N2831A-01

Modification Recommended Service Note

N2831A 8 GHz InfiniiMax III+ Series Probe Amplifier

Serial Numbers: US00000000 / US57270000

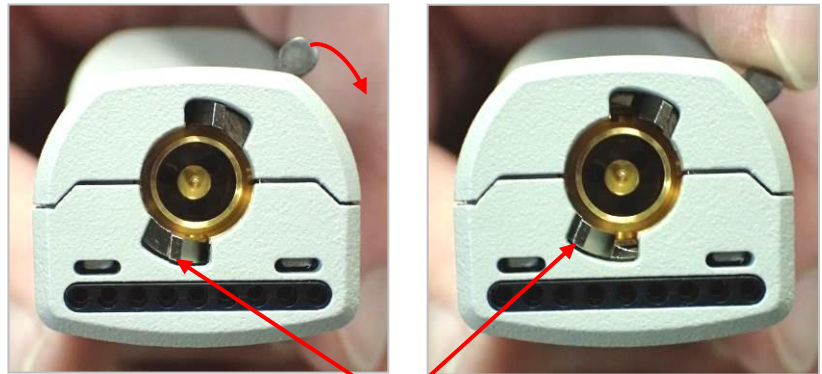
If the set screw is not stainless, it looks like the following after the sticker has been removed:

- a. If the screw is stainless, then remove adhesive and replace the label.
- b. No need to re-calibrate.
- c. If screw is black remove screw using T6 Torx.

Replace the current set screw under the product label to ensure cable ground connection to BNC ground.

BNC tab rotates with BNC latch rotation

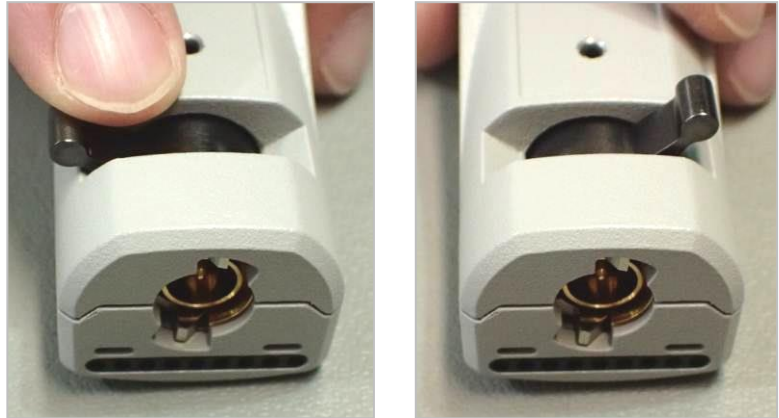
Below is what the new set screw should look like when inside the probe.

Install screw 0515-5534 Tighten T6 to 18 in oz.

Test the BNC connector by rotating the wing latch **clockwise**, and verify the BNC tab rotates inside the pod housing.
